Submission in Response to the Exhibition of the Environmental Impact Statement (EIS) for the Proposed Raising of Warragamba Dam (State Significant Infrastructure Development Application No. SSI-8441)

Submission in Response to the Exhibition of the Environmental Impact Statement for the Proposed Raising of Warragamba Dam (State Significant Infrastructure Development Application No. SSI-8441)

Figure 4-1: Water Level Timeseries at BLAXCROSS (Nepean River at Blaxland Crossing Bridge) (Source Table 15-21 of Chapter 15)

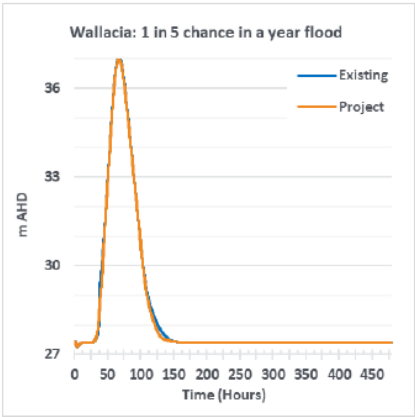
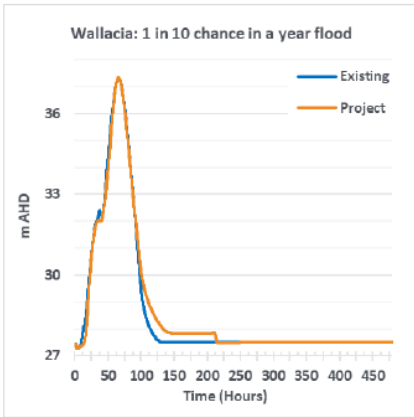
The water level timeseries at BLAXCROSS (Nepean River at Blaxland Crossing Bridge) for existing and projected dam wall raising scenarios are presented in **Figure 4-1**. The model results show whilst the peak flood levels are reduced for rare flood events the shapes of the hydrographs have not changed dramatically at Wallacia Village. This means that the time allowed for evacuation between the two scenarios has not been enhanced. This is particularly true for the more frequent storm events up to 1 in 20yr flood event. Conversely, the peak flood levels for rare flood events are predicted to go down bringing the number of inundated properties also down. This means less people need to be evacuated during the projected dam wall raising scenario. In the PMF event there is not much difference, existing scenario remain unchanged even with the projected dam wall raising scenario.

Figure 4-2: Water Level Timeseries at F4BRIDGE (Nepean River at M4 Motorway Bridge)
(Source Figure 4-32 of Appendix H1)

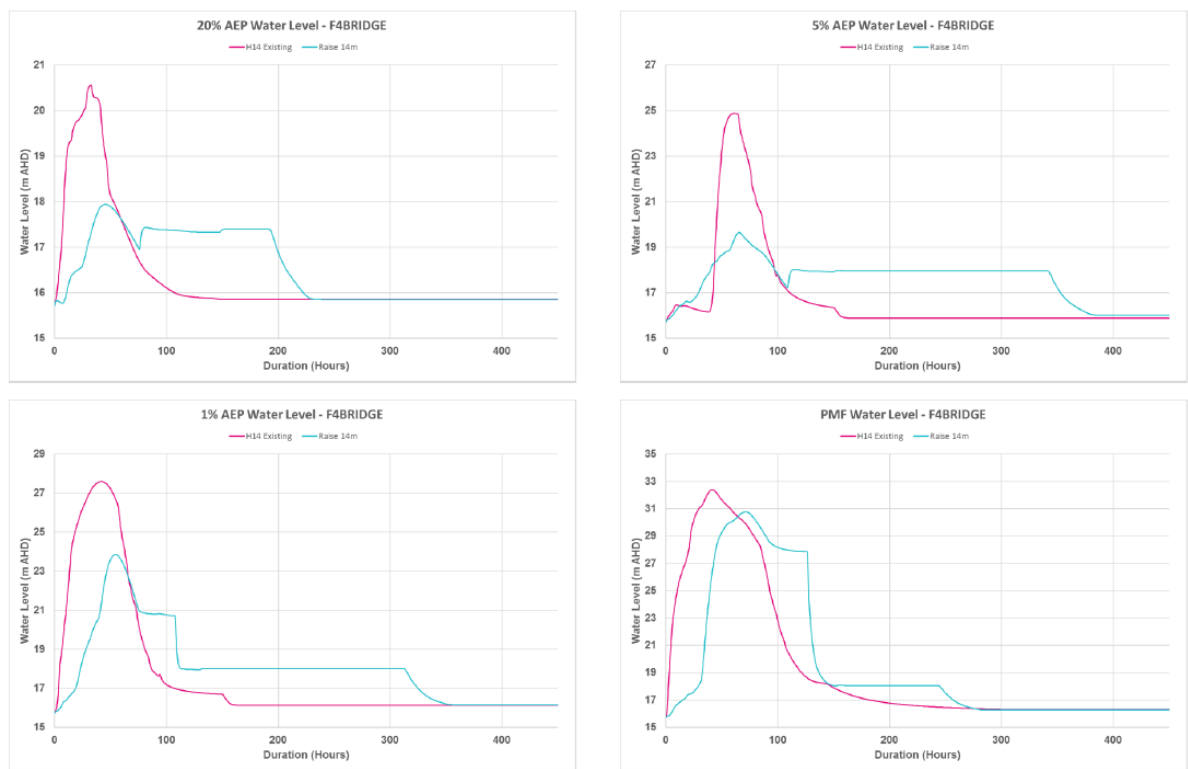
The water level timeseries for different design flood events at F4BRIDGE (Nepean River – M4 Motorway bridges) for existing and projected dam wall raising scenarios are presented in **Figure 4-2**. Similarly, the water level timeseries for other cross-sections are also presented in **Figure 4-3**. It is evident that both the flood frequencies and the shape of the timeseries are changed with the projected dam wall raising scenario. In addition to reducing the peak flood levels and associated flood extents, a raised dam wall will alter the period of inundation and rate of rise of floodwaters, allowing more certainty of time for people to evacuate, protecting lives, and reducing damages.

Figure 4-4: Water Level Timeseries at North Richmond (Source Table 15-21 of Chapter 15)

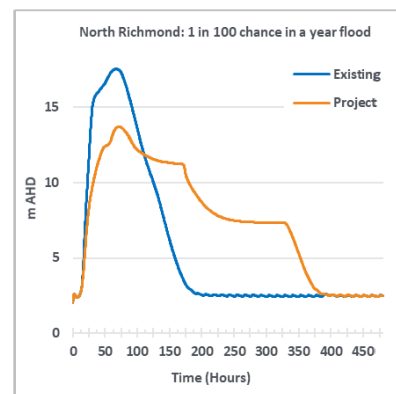
The timeseries graphs for Windsor Bridge are not supplied in the EIS, as an alternative the water level timeseries for North Richmond (sourced from Table 15-21 of Chapter 15) are presented in **Figure 4-4** to provide an indication of the rate of rise relevant to South Creek and Rickabys Creek areas. While, the peak flood levels and associated flood extents are reduced, there are now longer period of low flood to drain the water from the raised dam wall mitigation zone. This will alter the period of inundation and rate of rise of floodwaters, allowing more certainty of time for people to evacuate, protecting lives, and reducing damages.

Figure 3-32 Existing 1% AEP flood hazard mapping – Penrith (Source WMAWater 2019)

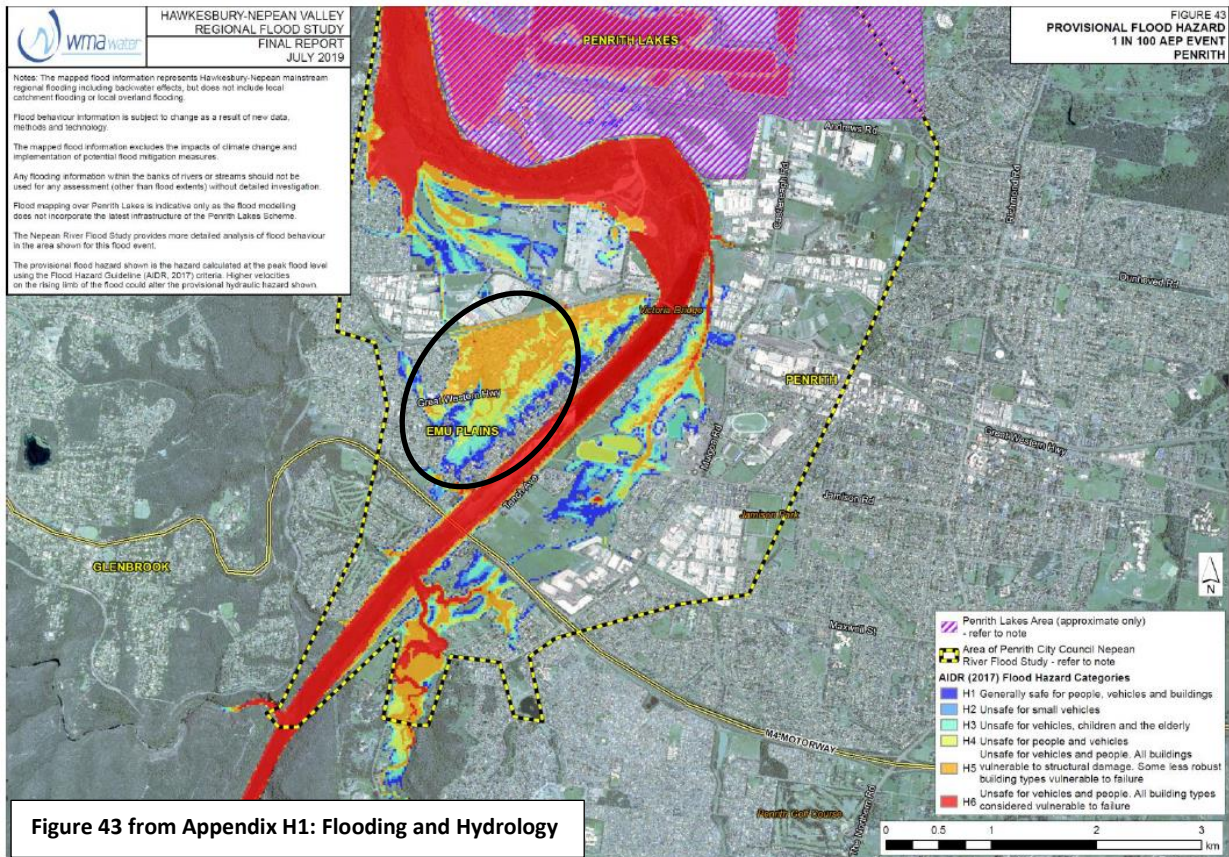
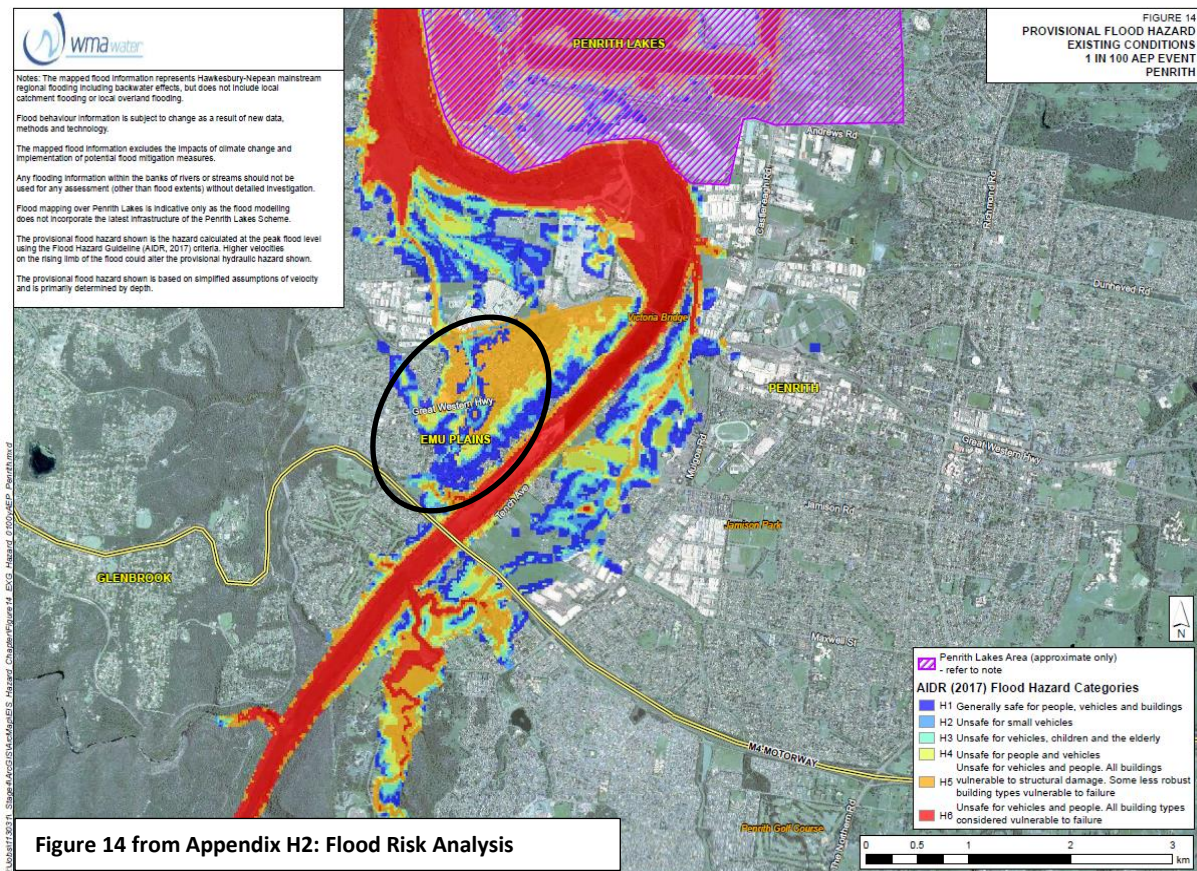
- For the existing condition, there are discrepancies between the results presented in Chapter 15 and Appendix H1 versus the results presented in Appendix H2. For example, comparing figure 3-32 of Appendix H1 to figure 43 of Appendix H2. It looks like the results are coming from two different sources. Refer to the series of figures at the end of this documents to clarify this point.

- The hazard results presented in Appendix H2 need a second review as they are not consistence across the flood events. For instance, in the same area of Emu Plains the 1 in 100yr flood hazard is higher than the 1 in 500yr flood hazard. Refer to the series of figures at the end of this documents to clarify this point.

Figures 14, 18 and 22 from Appendix H2: Flood Risk

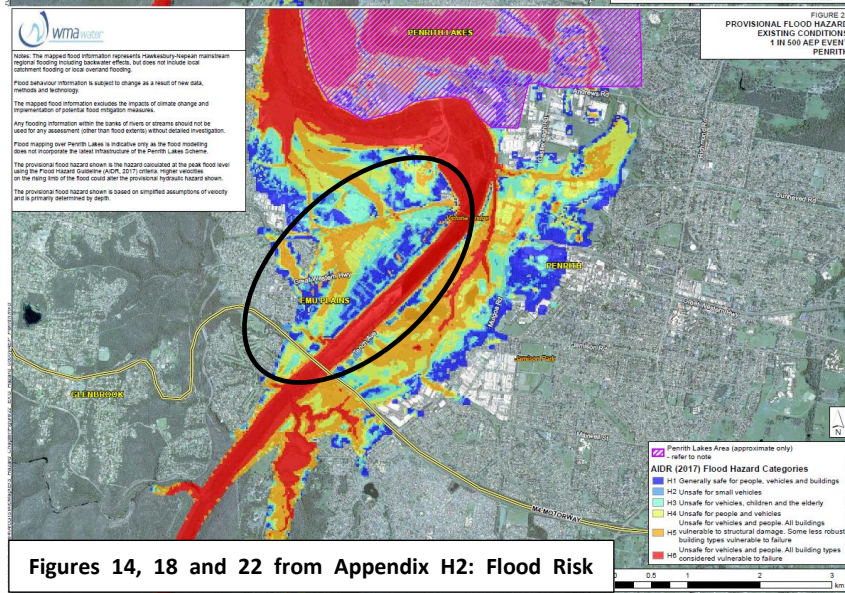
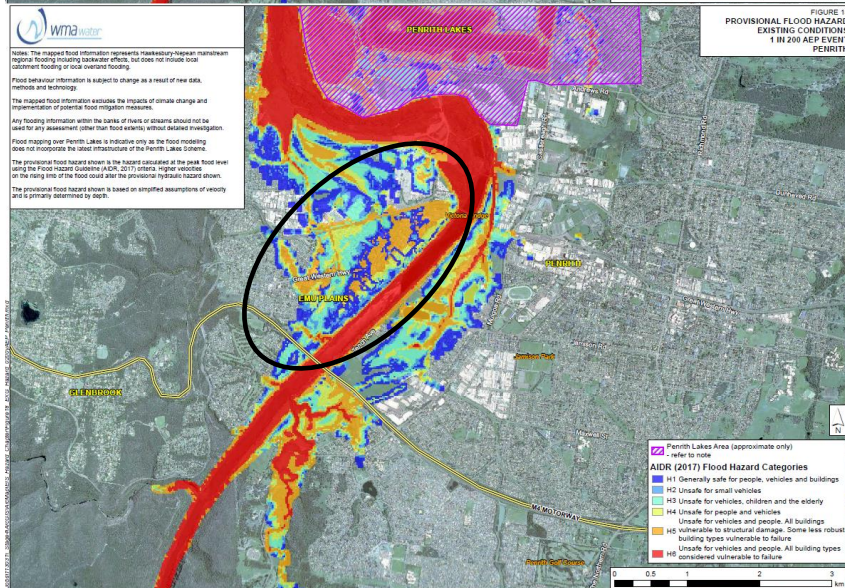
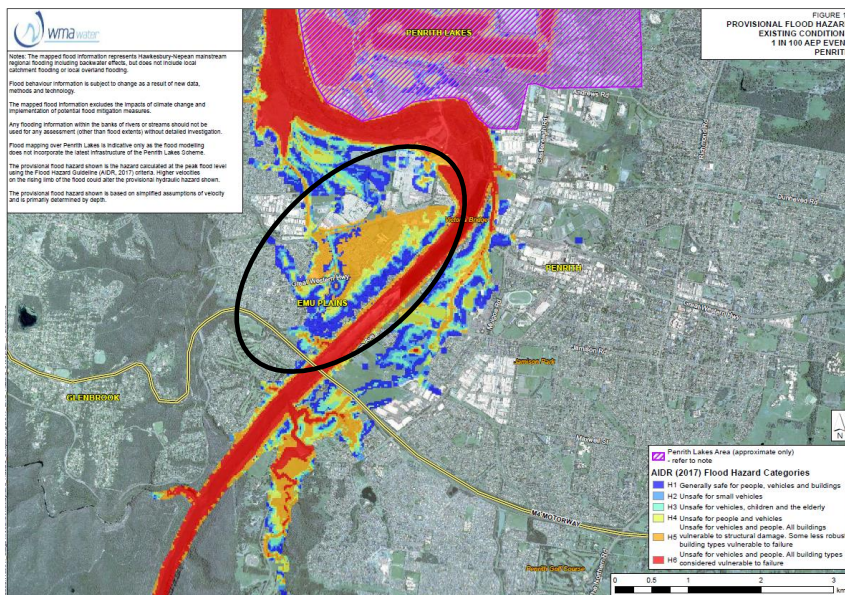
- In Appendix H2, the hazard results presented are also not consistence with the Hydraulic Categories results for the 1 in 100yr flood event in terms of extent. For instance, the hazard map doesn’t show backwater via Boundary Creek while the

hydraulic categories mapping does show backwater. The same comments apply to the proposed dam wall raising maps.
